Final Acceptance – Punchlist from DPW Stormwater

Project Name:	Bradley Storage
EDARP Filing Number(s):	PPR-17-011
ESQCP Number:	ESQ1917
Attendees:	DPW: Joshua Augustenborg, Ben Jones, Christina Prete, Glenn Reese, Brad Walters and David Parkerson Developer: Joshua Beggs
Date of Walk-Thru:	January 3, 2023
Walk-Thru Number:	1

Photo 12: Pond 1 rip rap rundown locations.

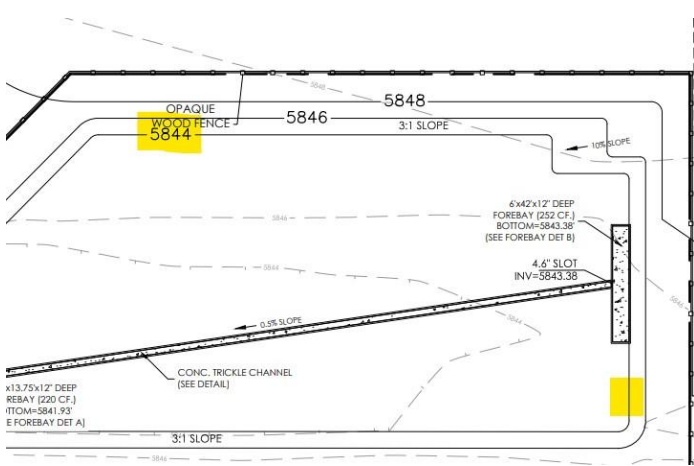
- Pond 1 Outlet Structure: Restrictor plate is missing three bolts that need to be replaced. Reference Photo 11.
- Pond 1 Rip Rap Rundowns: Two rip rap rundowns were installed in the field but not shown on the approved plans. Explain field change in the Pond Certification Letter and show locations on the As-Built Drawings. Reference Photo 12 and GEC Plan Sheet 7 of 19.
